**AGENDA**  
**PLANNING COMMISSION**  
**116 WEST NEEDLES**  
**BIXBY, OKLAHOMA**  
**January 19, 2016** **6:00 PM**

- (41) 2. **BZ-388 – Jessica Faubert.** Public Hearing, discussion, and consideration of a rezoning request from RE Residential Estate District and/or CG General Commercial District to AG Agricultural District for approximately 2.94 acres in part of the SE/4 of Section 22, T17N, R13E.

- (57) 3. **PUD 81 – “Chateau Villas PUD” – Major Amendment # 2 – Black Gold Group, LLC.** Public Hearing, discussion, and consideration of a rezoning request for approval of Major Amendment # 2 to Planned Unit Development (PUD) # 81 for approximately 23 acres in part of the NW/4 NW/4 of Section 01, T17N, R13E with underlying zoning CS Commercial Shopping Center District, RM-3 Residential Multi-Family District, and OL Office Low Intensity District.

- (67) 4. (Continued from 09/21/2015)  
**Final Plat – “Chateau Villas” – Cedar Creek Consulting (PUD 81).** Discussion and consideration of a Final Plat for “Chateau Villas,” approximately 23 acres in part of the NW/4 NW/4 of Section 01, T17N, R13E.

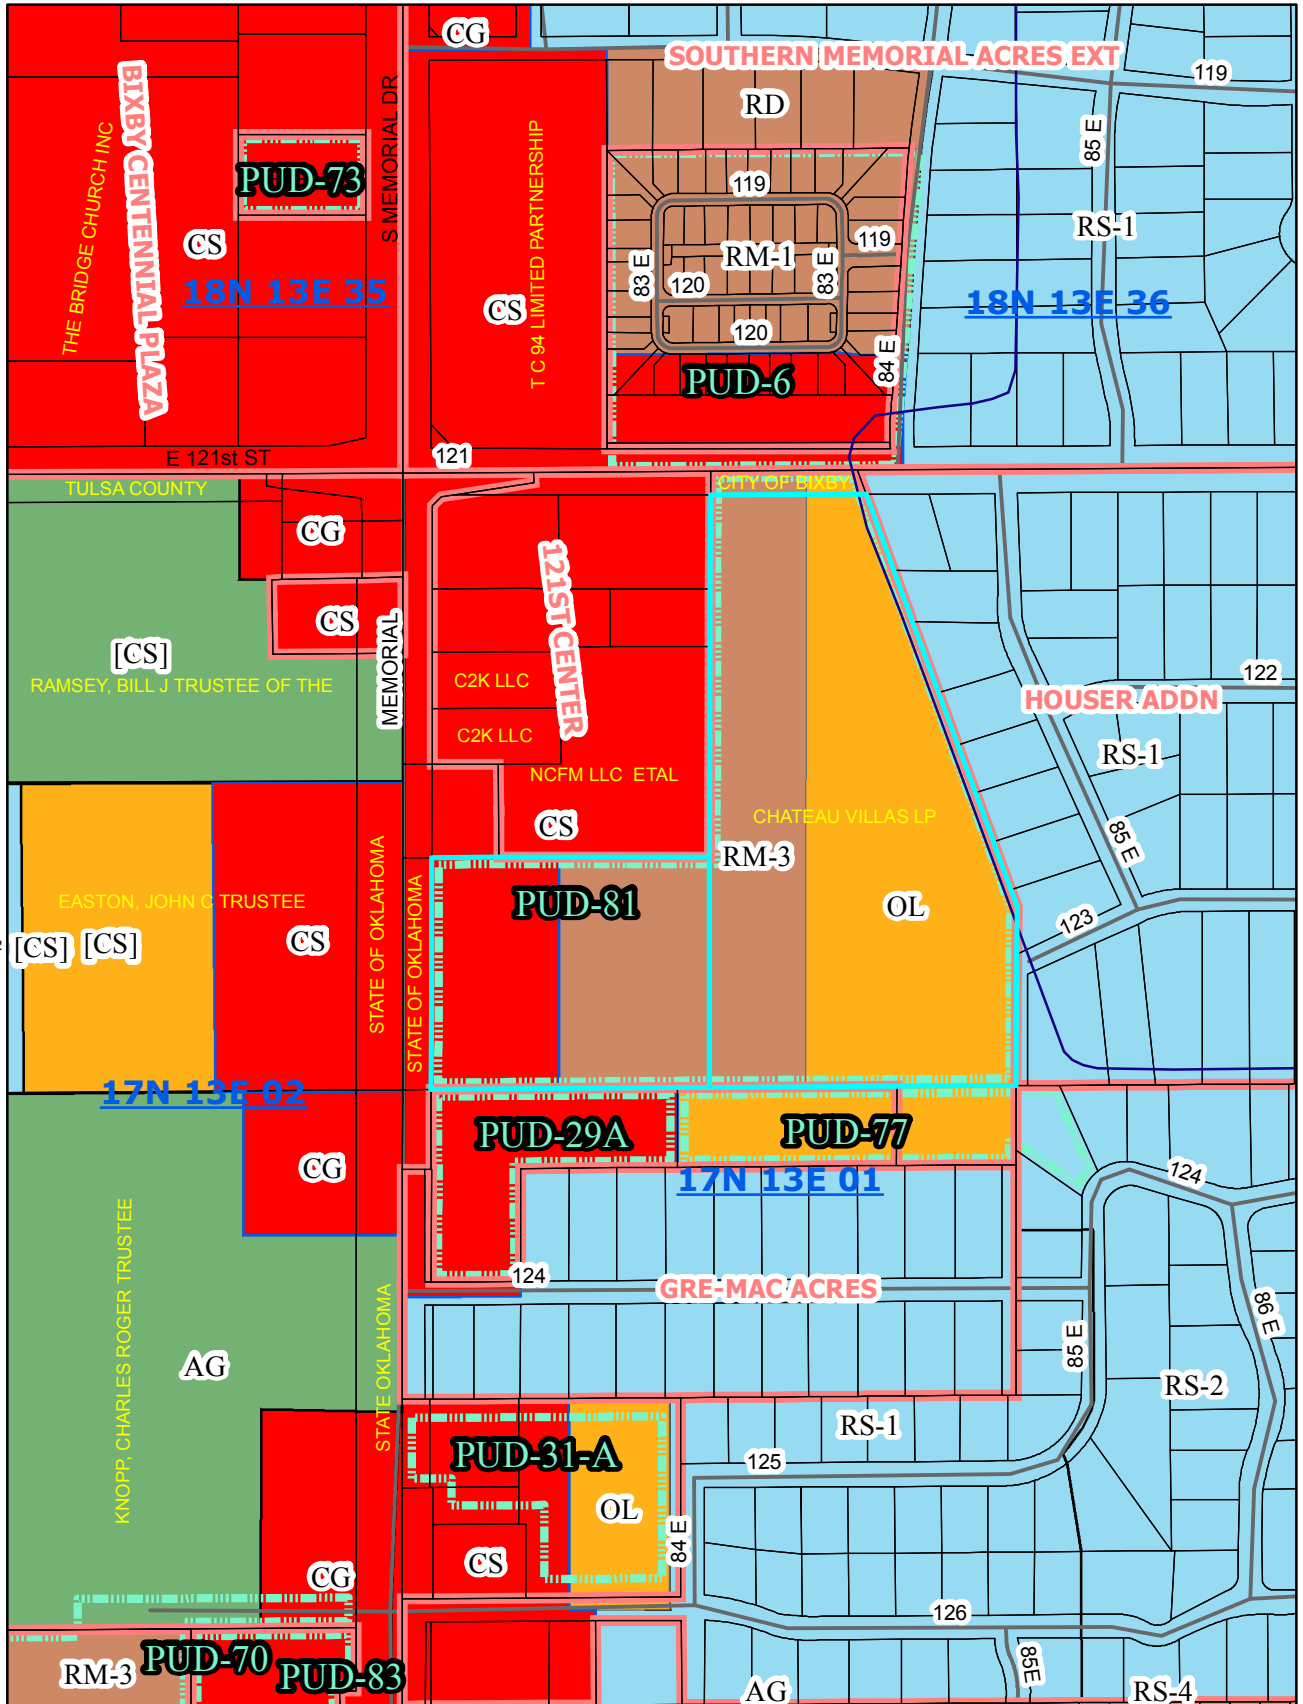
45. Face of Plat: Right-of-way dedication for 121<sup>st</sup> St. S.: please add width of dedication to "Right-of-way Dedicated by This Plat."
46. Reserve Area 'A' is 61' in width and there is a 15' B/L beyond. PUD 81 provides a 75' Zoning Setback / B/L. Please confirm intent to increase, by this plat, to 76', or advise.

47. Face of Plat: DoD/RCs Preamble: Final instance of "121st Center" has typo in term "Center."
48. Face of Plat: DoD/RCs Preamble: Equivocation of "Addition" and "Subdivision" does not appear to be appropriate. Please reconcile as per Condition of Approval of the Preliminary Plat and recommendation herein or advise.
